**Federal Aviation
Administration**

**Design and Implementation Team
Technical Report**

Cleveland/Detroit (CLE/DTW) Metroplex

November 7, 2017

Figure 5. Proposed Final Design DTW MIGGY ONE SID – Terminal View

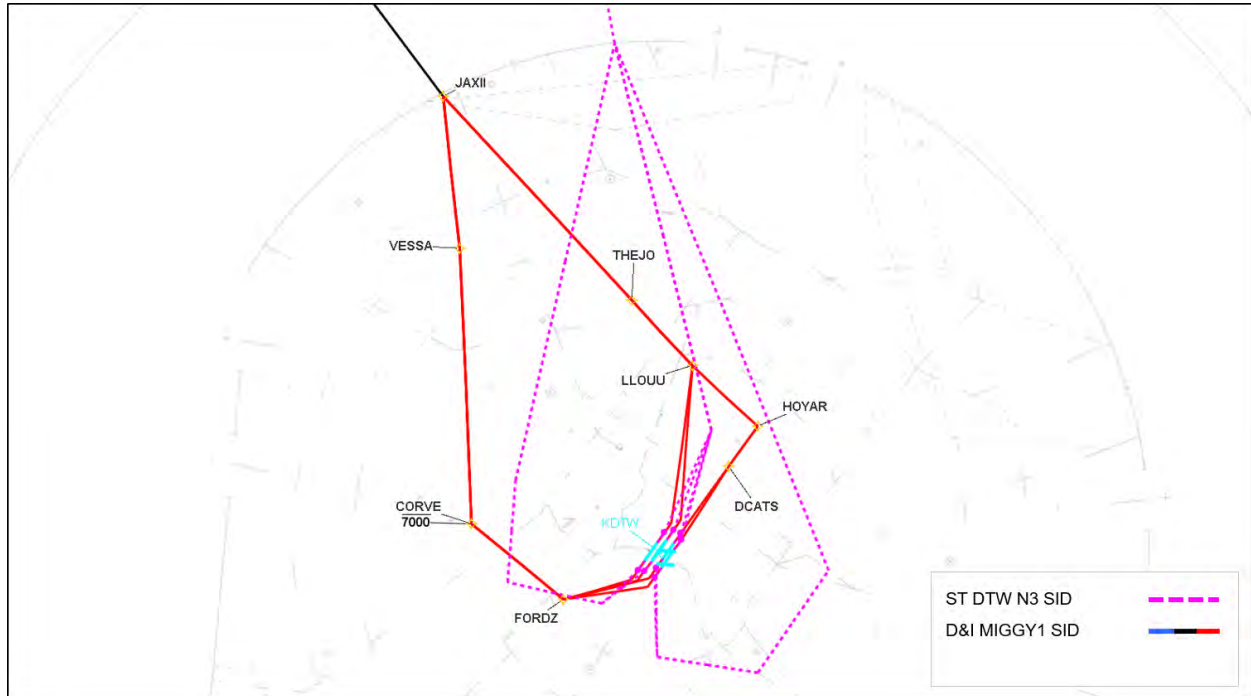
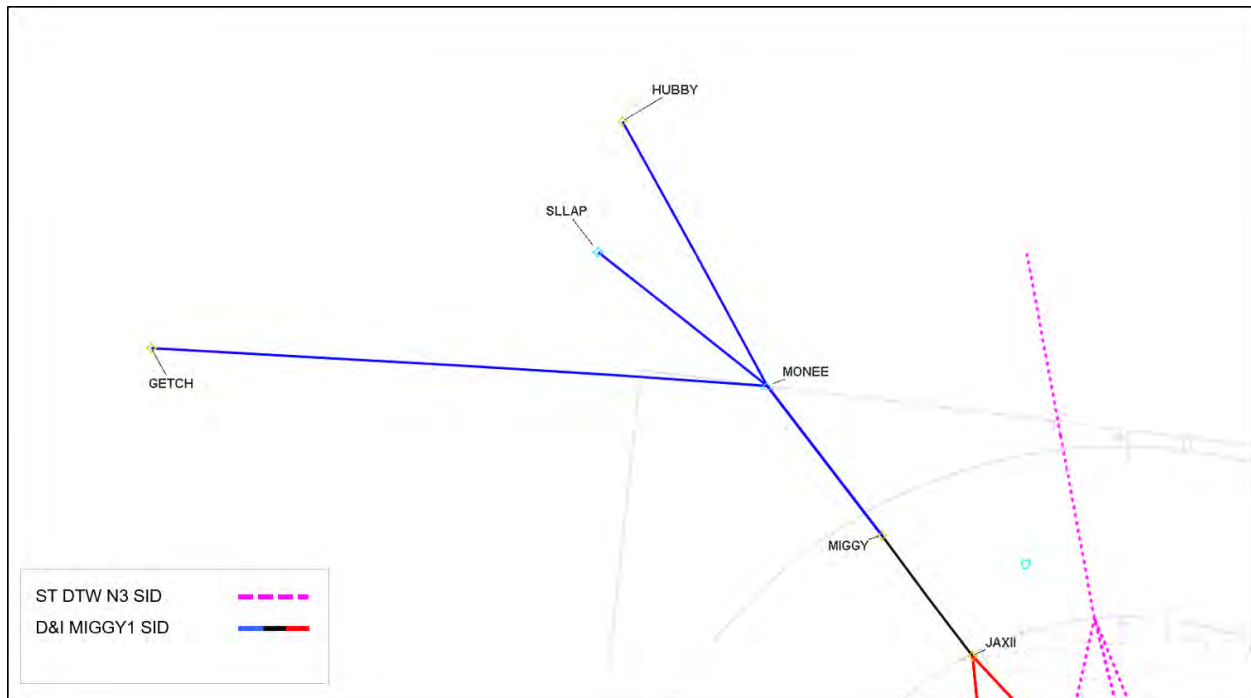
20170802	<p><u>DTW MIGGY SID</u></p> <p>) Moved the 03R transition over new waypoint BURPZ then HOYAR. Purpose: To deconflict the GGIBY/MIGGY from the transitions on the westbound SIDs.</p>	See above.	RW / MT
20170505	<p><u>DTW ZETTR SID</u></p> <p>) Changed the TANKO (identify as TANKO_) waypoint geographic coordinates from to read "lat. 43°01'32.48" N., long. 082°23'02.38" W." Purpose: Location as defined on Q-818 and Q-822 is being updated; actual location will not change.</p>	See above.	RW / MT
20170607	<p><u>DTW ZETTR SID</u></p> <p>) Moved the 04R transition over new waypoint KKELL then FLOKA (was over DCATS).) Moved the 04L transition over new waypoint MINDY then FLOKA (was over DCATS).) Moved the 03R transition over new waypoint BURPZ then FLOKA (was over DCATS). Purpose: To deconflict the ZETTR from the transitions on the eastbound SIDs.</p>	See above.	RW / MT

Figure 3. Proposed Final Design DTW PAVYL ONE SID – Terminal View

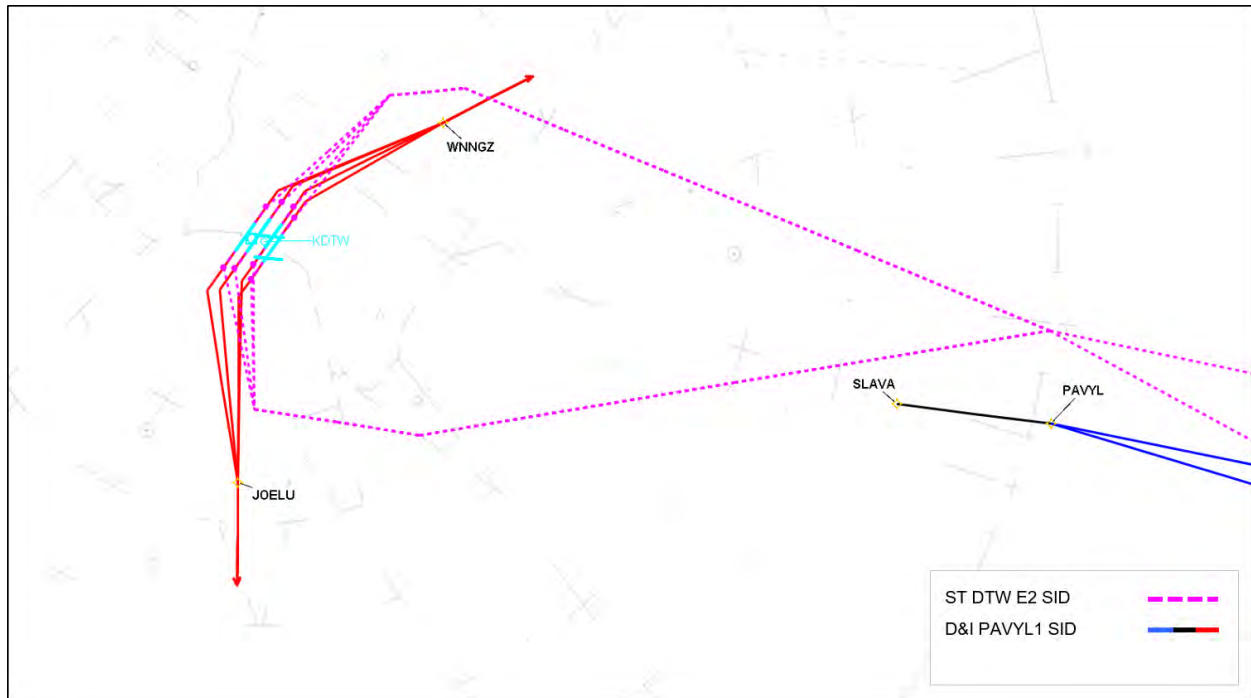
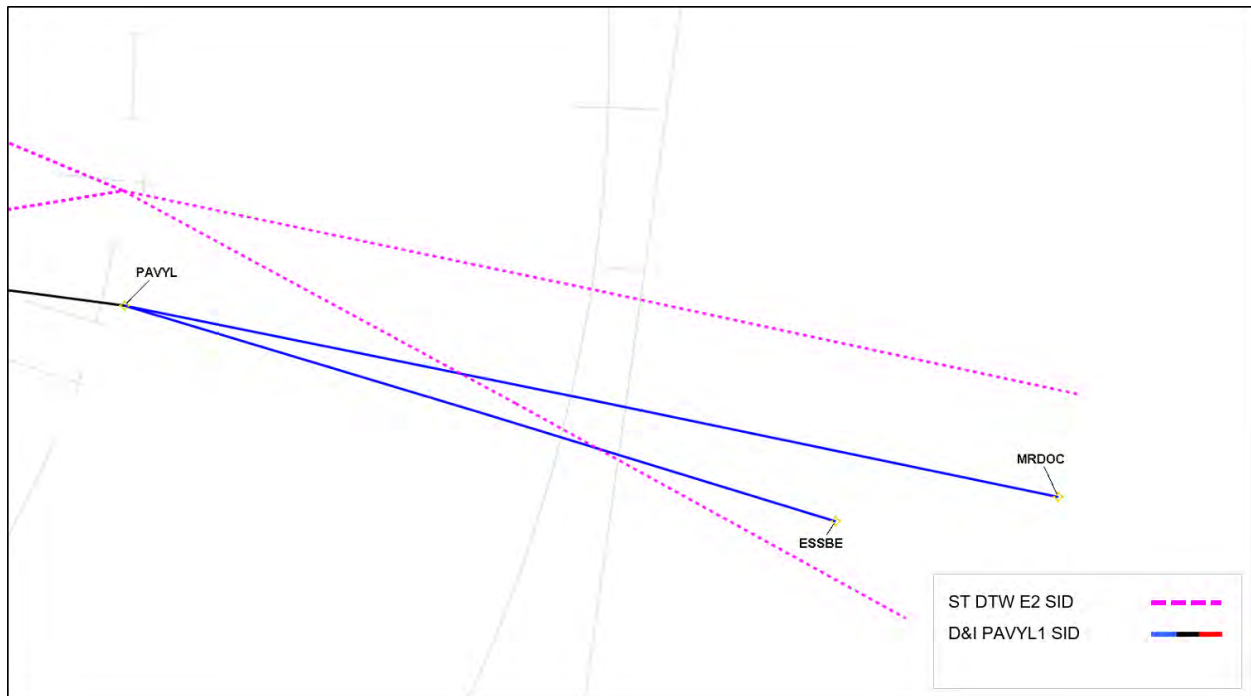
20170309	<p><u>DTW PAVYL SID</u>) Changed waypoint SLAVA to SLVVA. Purpose: SLAVA waypoint name not reserved. SLVVA is reserved.</p>	See above.	RW / MT
20170724	<p><u>DTW PAVYL SID</u>) Added AOA40 at KZLOV Purpose: To correct a criteria failure for required minimum or mandatory altitude at the IDF for SIDs with a radar vector component.</p>	See above.	RW / MT

Figure 1. Proposed Final Design DTW SNDRS ONE SID – Terminal View

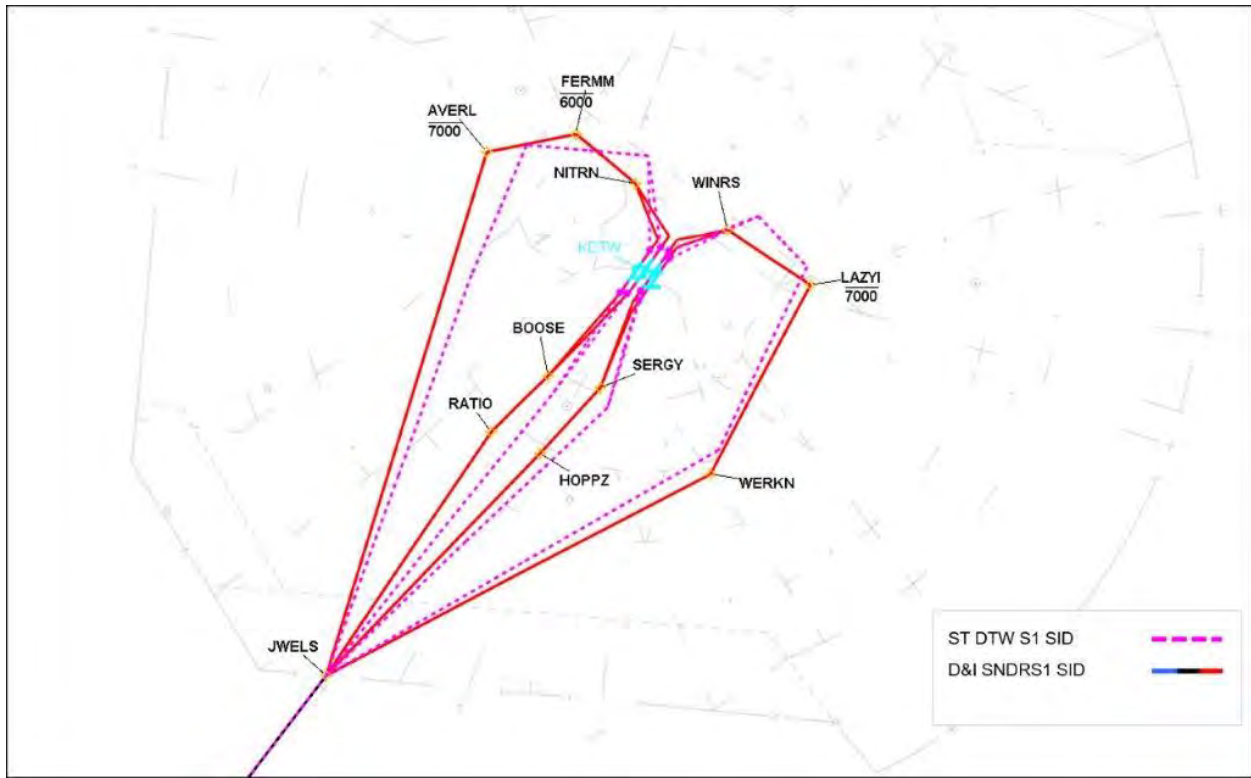
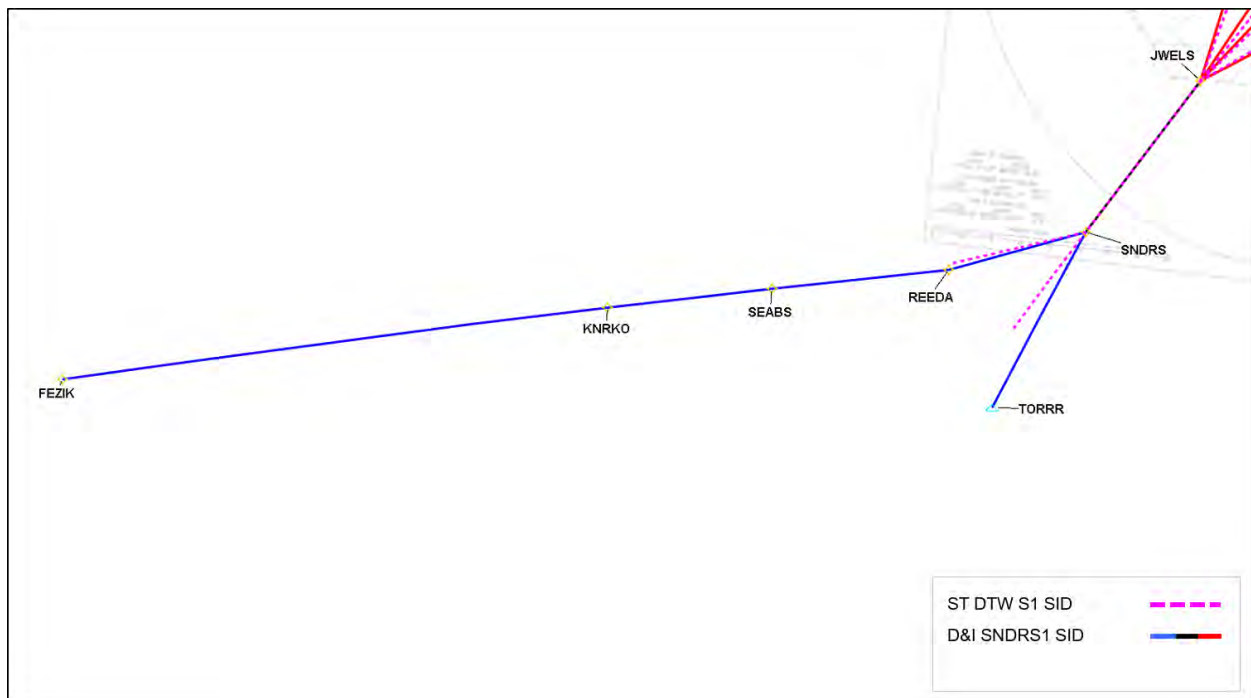
20170607	<p><u>DTW Sndrs Sid</u></p> <ul style="list-style-type: none">) Moved BOOSE waypoint to N42 10 08.18 W83 23 45.01) Moved the 22R transition over new waypoint EEERI then RATIO (was over BOOSE). <p>Purpose: To deconflict the BARI/CLVIN/SNDRS from the transitions on the westbound SIDs.</p>	See above.	RW / MT
20170724	<p><u>DTW Sndrs Sid</u></p> <ul style="list-style-type: none">) Added AOA40 at JWELS) Renamed WINRS waypoint to BESST <p>Purpose: To correct a criteria failure for required minimum or mandatory altitude at the IDF for SIDs with a radar vector component. To avoid confusion between WINGZ and WINRS (DTW ATCT requested)</p>	See above.	RW / MT

Figure 5. Proposed Final Design DTW CLVIN ONE SID – Terminal View

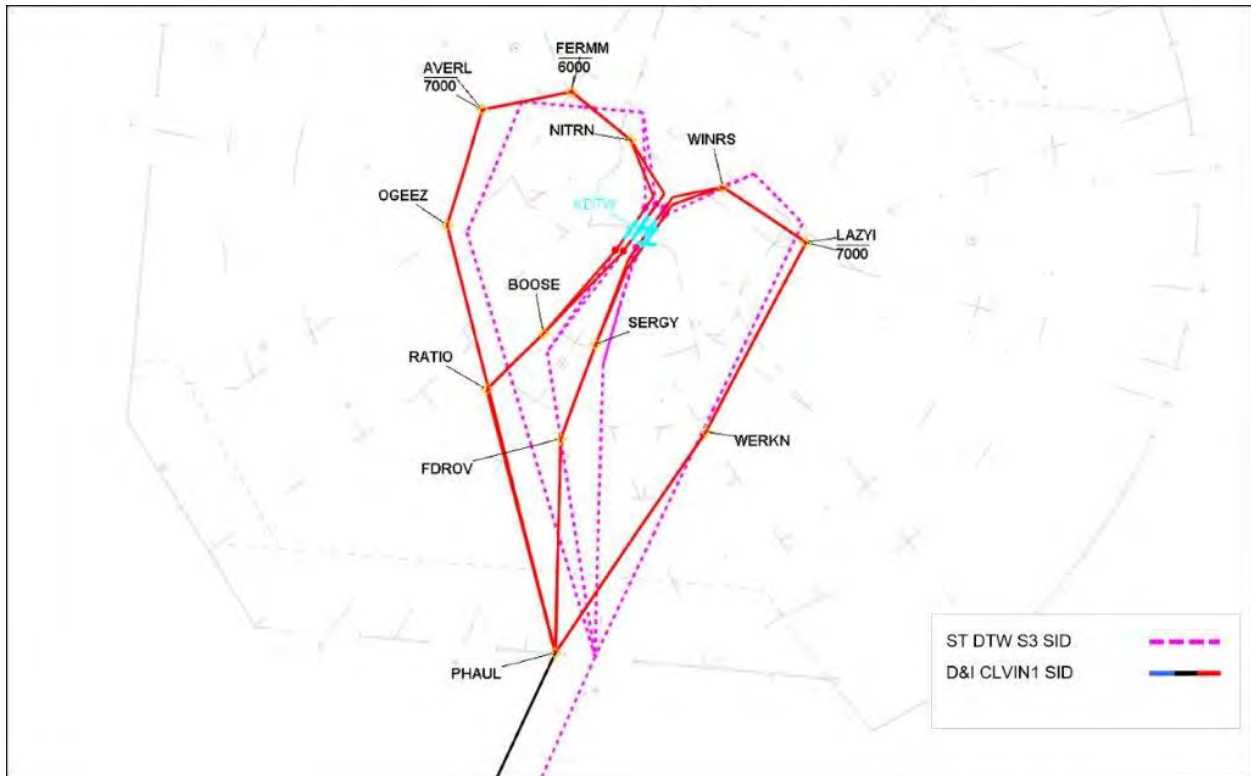
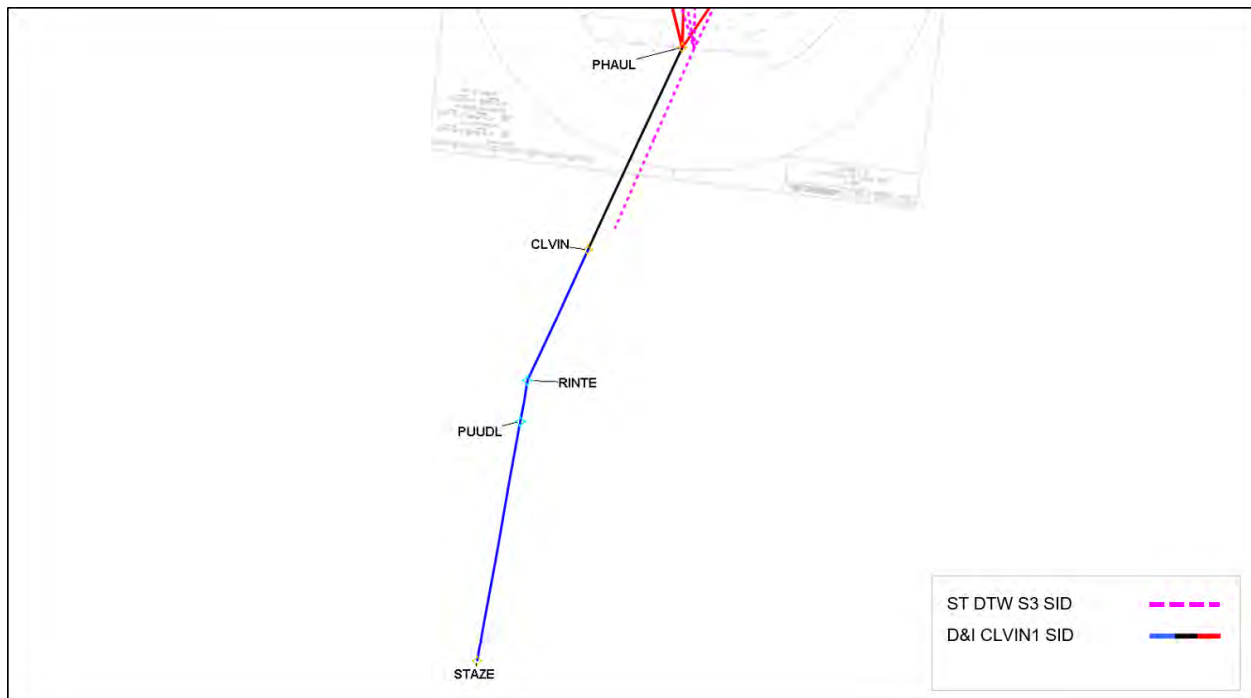
20170309	<p><u>DTW CLVIN SID</u></p> <ul style="list-style-type: none">) Changed waypoint FERMM to FERRM. <p>Purpose: FERMM waypoint name not reserved. FERRM is reserved.</p>	See above.	RW / MT
20170607	<p><u>DTW CLVIN SID</u></p> <ul style="list-style-type: none">) Moved BOOSE waypoint to N42 10 08.18 W83 23 45.01) Moved the 22R transition over new waypoint EEERI then RATIO (was over BOOSE). <p>Purpose: To deconflict the BARI/CLVIN/SNDRS from the transitions on the westbound SIDs.</p>	See above.	RW / MT
20170724	<p><u>DTW CLVIN SID</u></p> <ul style="list-style-type: none">) Added AOA40 at PHAUL) Renamed WINRS waypoint to BESST <p>Purpose: To correct a criteria failure for required minimum or mandatory altitude at the IDF for SIDs with a radar vector component. To avoid confusion between WINGZ and WINRS (DTW ATCT requested)</p>	See above.	RW / MT
20170309	<p><u>DTW SNDRS SID</u></p> <ul style="list-style-type: none">) Changed waypoint FERMM to FERRM. <p>Purpose: FERMM waypoint name not reserved. FERRM is reserved.</p>	See above.	RW / MT
